# MISCELLANEOUS MODELS INFORMATION & SERVICE BULLETINS

Manual P/N 0298  
(05/04)

**Alamo Industrial**  
P. O. Drawer 549  
Seguin, Texas 78155  
830-372-3551

**2004 Edition**

Figure 1

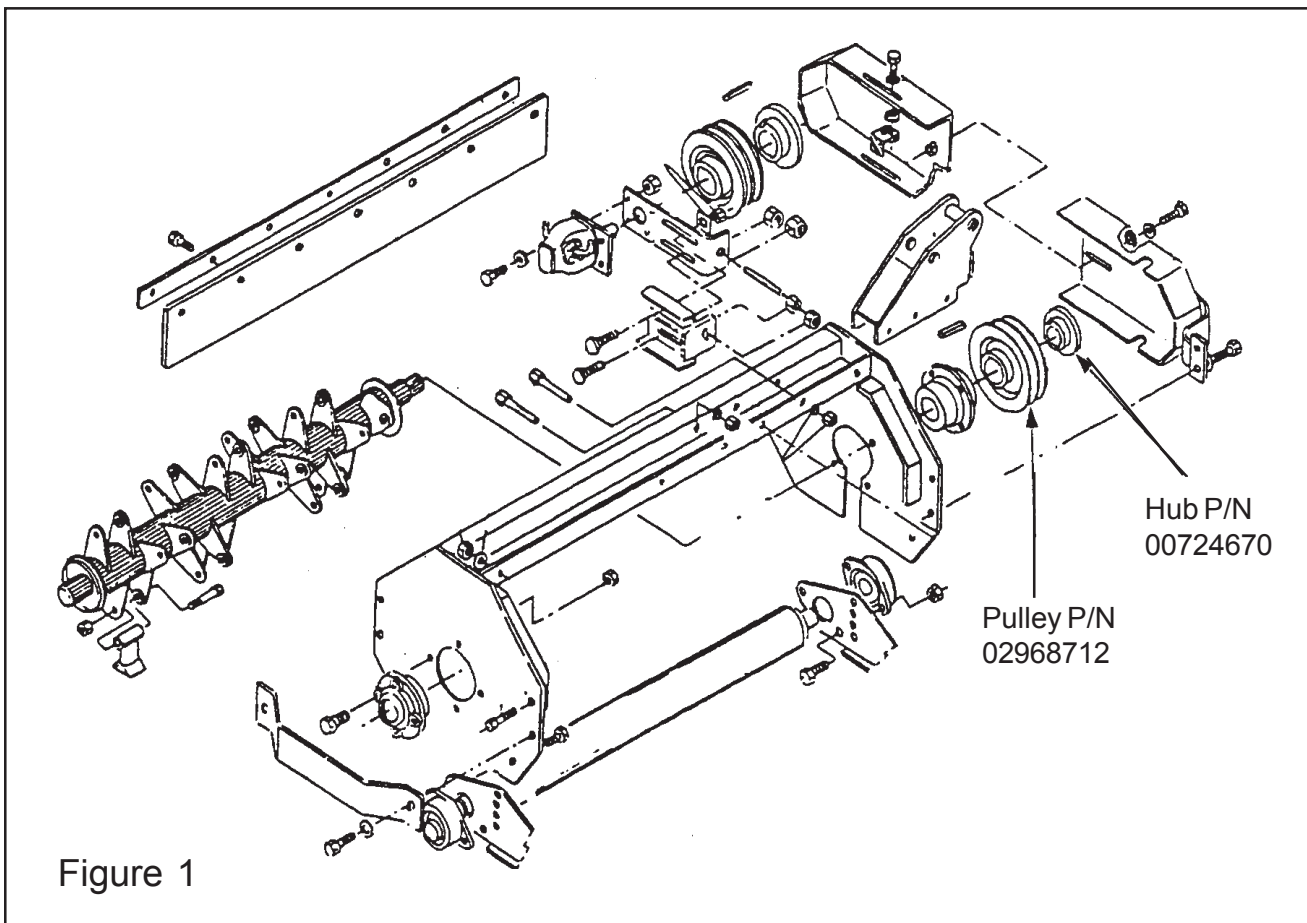
A new method has been devised to secure the pulley to the cuttershaft. A new pulley, P/N 02968712 and a QD Pulley Hub P/N 00724670 has replaced the old pulley with setscrew, washer, lockwasher and bolt. The new pulley and hub are a keyed, taper lock design which will provide a better fit and longer service life for the shaft.

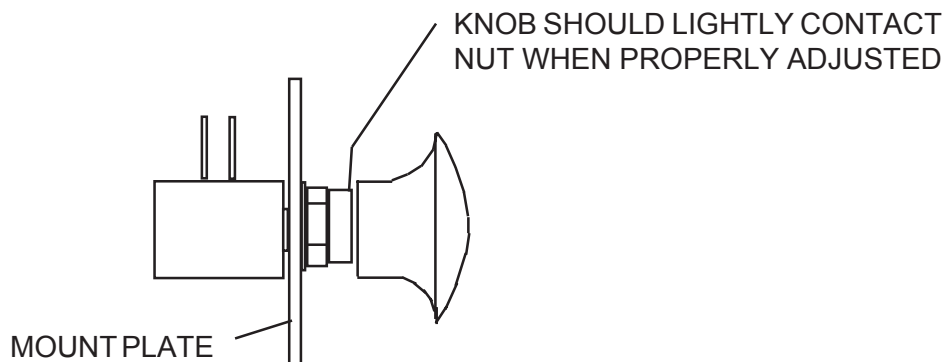
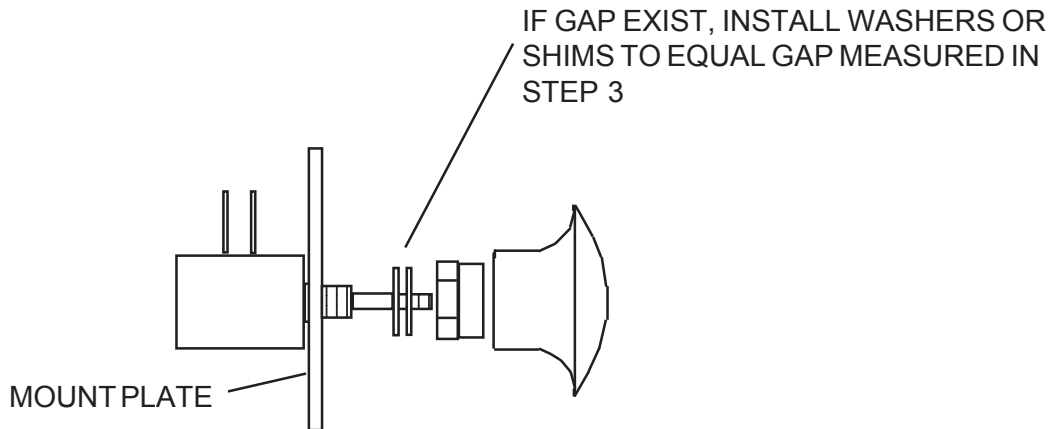
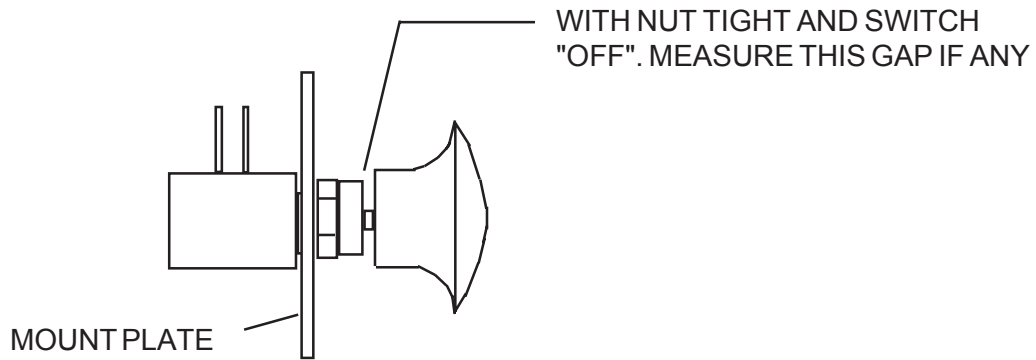
- (a) Knob pulls off rod.
- (b) Rod and Knob pulls out of switch body.

Test performed on numerous switches indicates that the (b) failures are due to excessive force being applied to the knob when shutting off the mower. Specifically, the knobs are usually roughly slapped to turn the mower off. After internal parts of the switch are damaged, the rod can then be pulled out easily. The (a) failures are due to the knobs not being securely tightened.

To prevent these failures from occurring, or to replace a damaged switch, use the following procedure to adjust the travel of the switch. (See attached diagram).

1. Install the switch body in the holder and tighten the nut.
2. Screw the Knob on the rod to the bottom of the thread, but do not overtighten. It will probably be necessary to hold the rod with pliers to get the knob tight, if you do use caution not to score the rod with the pliers.

3. Measure the distance (if any) between the knob and the nut. Record the measurement.
4. If a Gap exists between the knob and the nut, remove the knob.

5. Remove the nut and install the same thickness of flat washers that was measured in step 3. Install and tighten the nut> DO NOT install more washers than needed to take up the space. Flat Washer Part No. 00023500 or equivalent can be used.

### Buzz Bar Drive Coupling Design change:

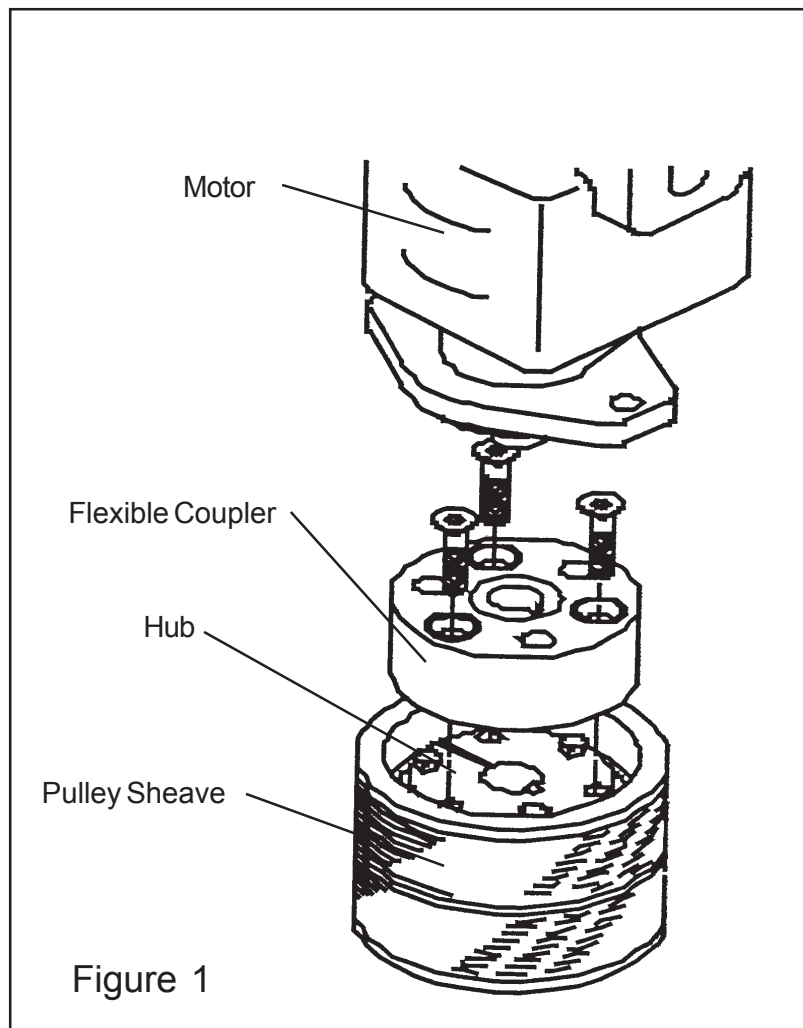
There has been a design change to the drive coupler assembly for the Buzz bar Cutting Head. If a flexible coupler, Alamo Industrial P/N 02974245 (for Machete) or P/N 02974246 (for A-Boom & Slopemower), are ordered they will be a different design. The new flexible coupler design will be molded rubber with metal inserts. The new molded rubber version will directly replace the machined design using the same part number. An installation drawing, that describes the assembly in detail, will be shipped if a new coupler is ordered. this bulletin is to inform you of the design change (see Figure 1) If there are further questions please contact Alamo Industrial's Technical Service Department.

### Pulley Adapter Mounting Bolts Ford 56, 66 & 7740 Tractors:

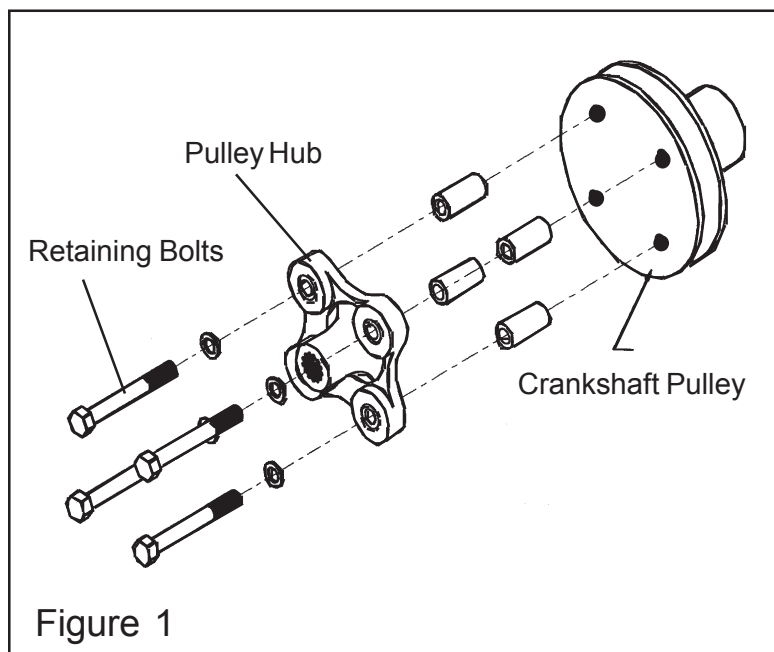
7/16" bolts holding Hub to Tractor Crankshaft Pulley found to need more engagement into pulley (longer bolts required).

1. Remove the four retaining bolts from Hub where it mounts to Tractor crankshaft Pulley. The old bolts were 3-1/4" long (P/N LH0B128B) the new replacement bolts need to be 3-1/2" long (P/N 02965355 longer bolts).
2. Use "locktite on new bolts and install them into the hub and pulley, tighten the bolts to retain hub to crankshaft pulley.
3. Run and test for operation.

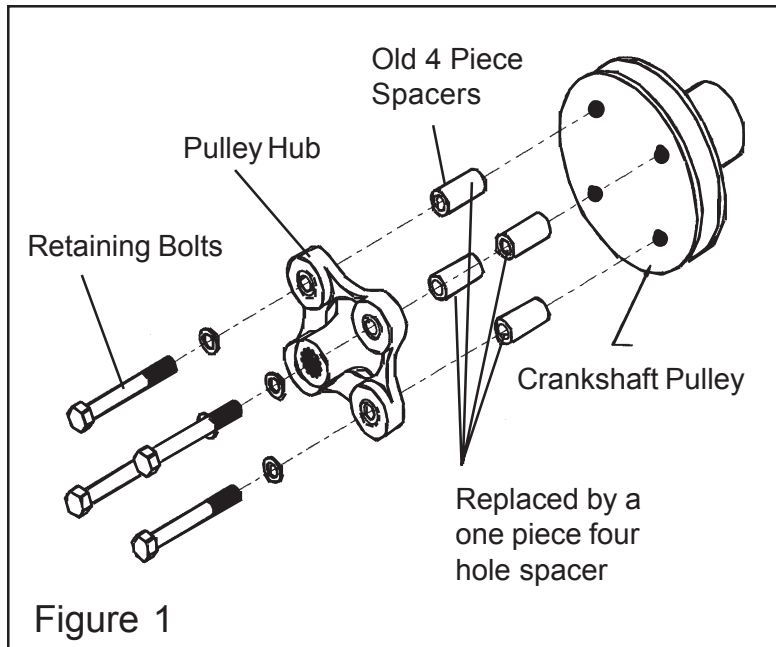
Spacers used in driveline between Hub and crankshaft pulley change. Spacers and bolts between hub and pulley on Ford 5640, 6640 and 7740 tractors need to be longer.

1. Remove the four retaining bolts from Hub where it mounts to Tractor crankshaft Pulley, remove the 4 spacers P/N 107620. Discard these spacers they will not be used.
2. Using the existing 4 bolts P/N 02965355 (3-1/2" long) and lockwasher P/N 00022200, reinstall the hub using the new one piece spacer P/N 02966404. (6640 & 7740 Models Only)

Note: 5640 model tractor use Kit 02965750 instead of parts listed above in step 2, the kit will include spacer and four new 4" bolts for the 5640 model Tractor. The procedure will be the same but the parts will be different.

Figure 1

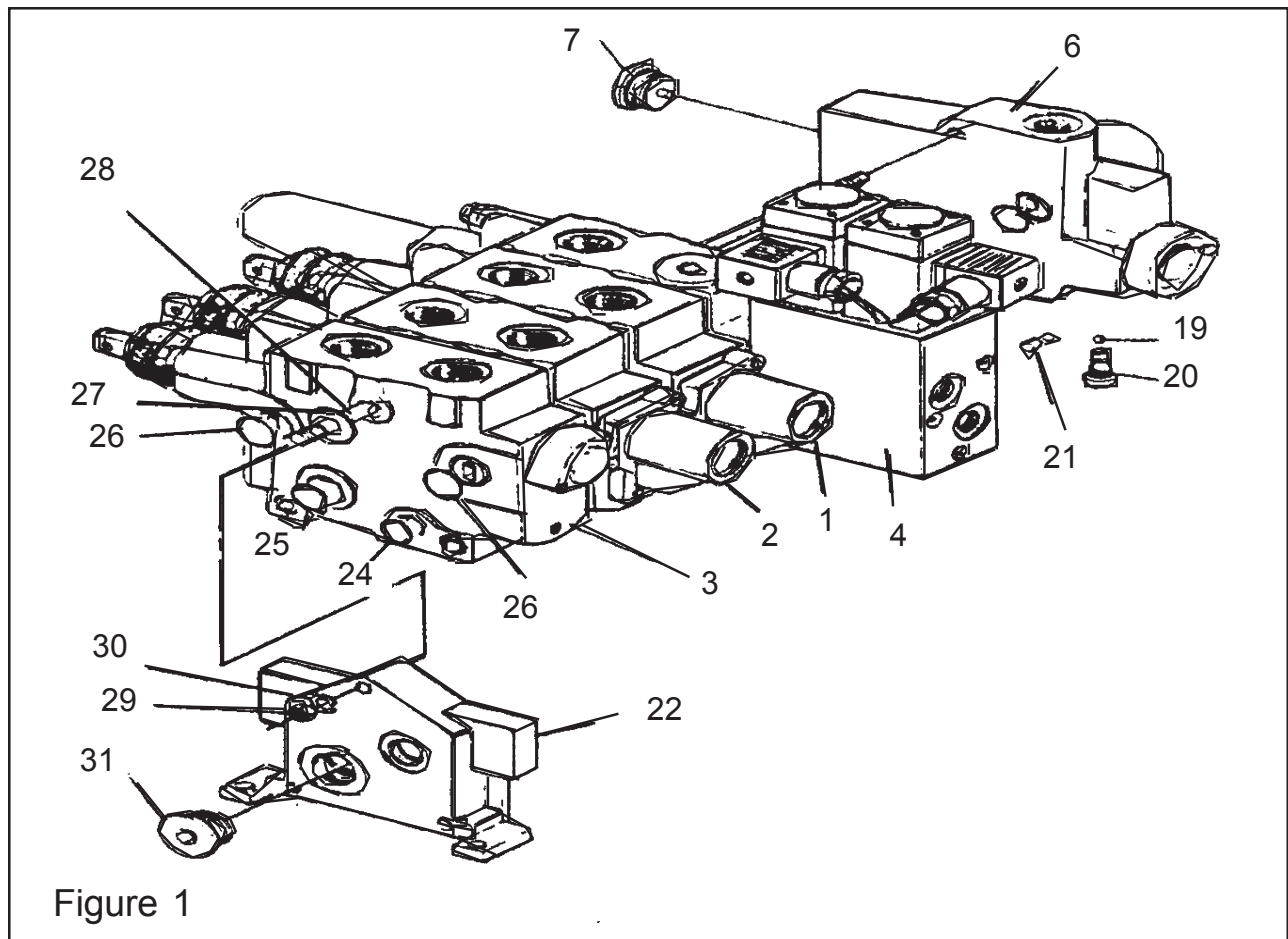
### Removal of Standard Valve: (see Figure 1)

1. Remove the spool control link of the standard valve section (item 3) at the control shaft arm by removing the cotter pin and the drilled in on the end of the valve section.

2. Remove the hoses that are connected to the valve end plate and the hoses connected to the standard valve section.
3. Remove the valve assembly support bolt on right hand side. Remove nuts and lockwashers from the three valve tie bolts (item 29 & 30).

4. Remove the Valve end section (item 22). Note there are shims between each section on the same side as the O-Rings, one shim per tie bolt, do not lose them (See Figure 1).

5. Remove the flow control adjustment cable from the standard valve section and remove the section. Turn the spool until the setscrew is accessible.
6. Install O-Rings in the new Float Valve Section using a small amount of white lithium grease to hold them in place. Transfer the spool control link from the Standard Valve Section to the new Float Valve Section

1. Reinstall float valve section in place of standard valve section in reverse of removal making certain there is one shim on each tie bolt between each section. Make certain all O-Rings are in place, keep close watch on O-Rings to make certain none fall out during assembly.
2. Install flow control cable before installing end section. Flow control spool should be set at the minimum setting - all the way clockwise. The flow control knob in cab should also be turned to the minimum setting. Securely tighten the setscrew.

Figure 1

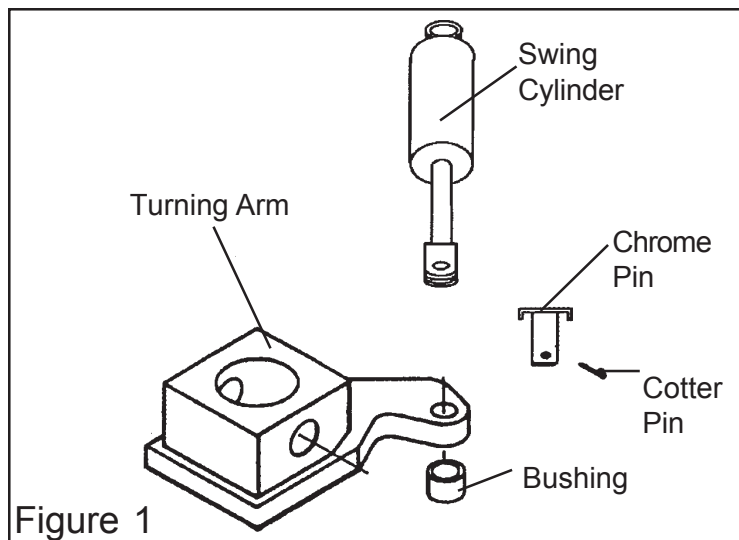
Premature wear of teflon coated swing cylinder bushing. To replace the swing cylinder bushing on unit built prior to June 1994 if premature wear in swing cylinder bushing occurs.

1. With Boom Arm extended outward and Head resting on the ground, Tractor secured in a safe manner. You will not have to remove any hydraulic lines to perform this repair.
2. Remove Swing cylinder pin, this is the old pin that connects it to the turning arm. The swing cylinder will pull away from turning arm far enough that only this end needs be disconnected.
3. Using a suitable driver remove the old bushing from the turning arm.
4. Check the condition of the bore in the turning arm, if damaged repair or replace turning arm.
5. Install new bushing (P/N 02965548) using a suitable driver. Slide cylinder back and align the holes, insert the new chrome pin (P/N 02966767), install the cotter pin (P/N 00606000).
6. Run and test operation of unit.

Part No.	Qty	Description
02966767	1	Chrome Pin
02965548	1	Bushing
00606000	1	Cotter Pin

Figure 1

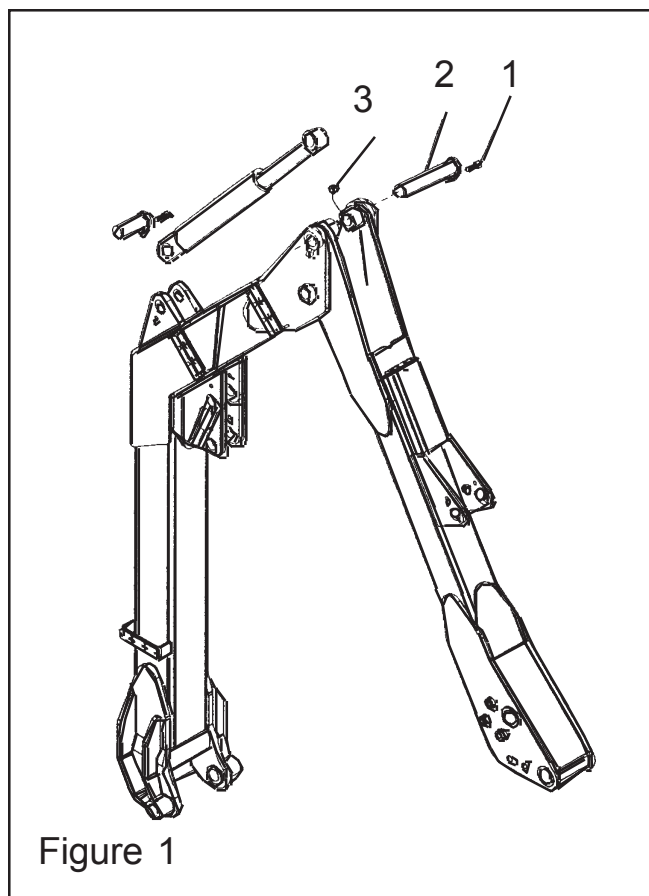
Replace Old Pin P/N 02966936 dipper cylinder pin with New Pin P/N 02969980, P/N 02030300 Nut and P/N 00749946 Washer. **Mowers equipped with 02966936 dipper pin (old pin can be identified by absence of a nut on the end of the pin).**

1. Rest Head on the floor (or ground) with dipper cylinder accessible. Make certain all hydraulic pressure is relieved from Hoses and cylinder system.
2. Secure and support dipper with hoist to prevent movement when pin to dipper cylinder is removed.
3. Replace the original pin P/N 02966936 with the new pin P/N 02969980, nut P/N 02030300 and washer P/N 00749946.
4. Tighten Nut and retaining bolt. Remove Hoist from dipper.
5. Run and test for operation

Part No.	Qty	Description
02969980	1	Dipper Cyl. Pin
02020300	1	Nut
00749946	1	Washer

### Blade Bolt Inspection / Recall:

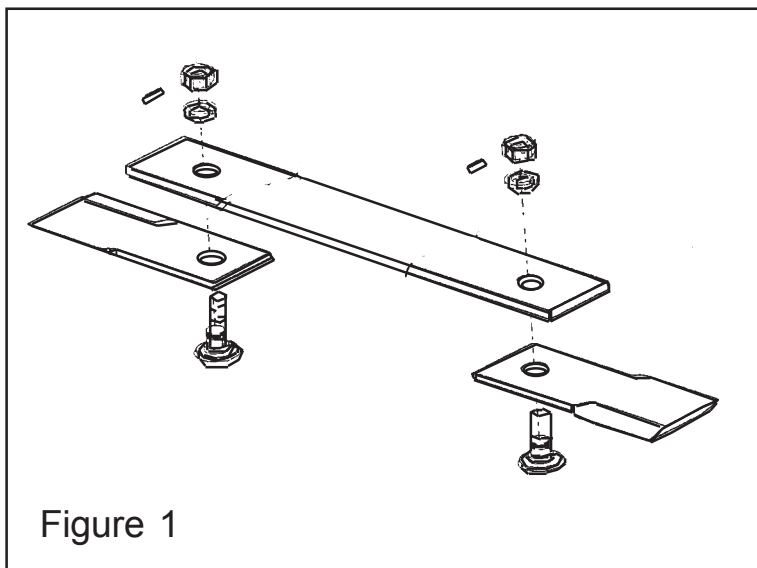
The Blade Bolt Nut Retaining Roll Pin Bore may be oversized and could allow the roll pin to become loose in the bore. The loose roll pin could therefore allow the blade bolt Nut to loose torque.

1. Visually inspect and check the fit of the roll pin. If it is loose or has come loose replace the Blade Bolt, Blade Bolt Nut and Roll Pin on the above listed serial numbered units.
2. Torque the Blade Bolt to 600 ft. lbs. before installing the new Roll Pin.

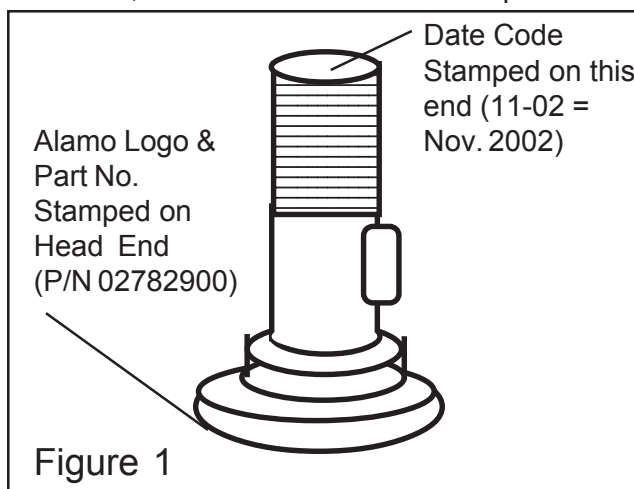
Quality inspections revealed the potential for cracking of the Blade Bolt. Cracks are the result of manufacturing procedures and will be present on the bolts prior to installation on the mower. This is pertaining to a Date code which is stamped on the threaded end of the bolt, Date Code 11-02.

1. Inspect all Bolts in Parts stock and those on the effected mowers by checking the dated code on the Blade Bolt.
2. If Blade Bolts do not have the 11-02 date code no service will be required.
3. If the Date code 11-02 is there check the Bolt for any cracks in them, If the bolts are installed on the mower they will have to be removed to check.
4. If they check OK reinstall them and torque them to 600 ft. lbs. and reinstall roll pins.
5. If they have cracks replace them with new ones, install the new bolts and torque to 600 ft. lbs. Reinstall roll pin.

### Blade Carrier Retaining Bolts:

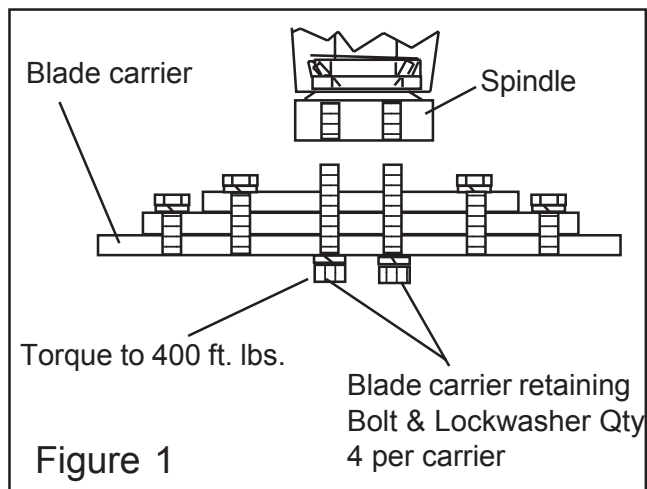
**Subject:** Due to the Possibility of Bolts that may not meet Alamo Industrial Standard being used in the production process all bolts that meet the Serial Number list below should be changed. This will apply to bolts that were used at factory during assembly process, This WILL NOT include Bolts that were used as replacement parts. If you have a model with the following serial numbers replace the bolts and Lockwashers. Because there are more than one length of Bolt involved it will be required to use the appropriate Parts Manual to determine the Bolt and Washer Number that applies to your model.

1. Remove the Four Allen Head Bolts in the center of the Blade Carrier one bolt and Lockwasher at a time. DO NOT remove all four bolts at one time and DO NOT INSTALL bolts that are longer or shorter than bolts that were removed.
2. Replace one Bolt and Lockwasher, torque it to 400 ft. lbs. then move on to the next bolt.
3. Continued this until all four bolts have been replaced.
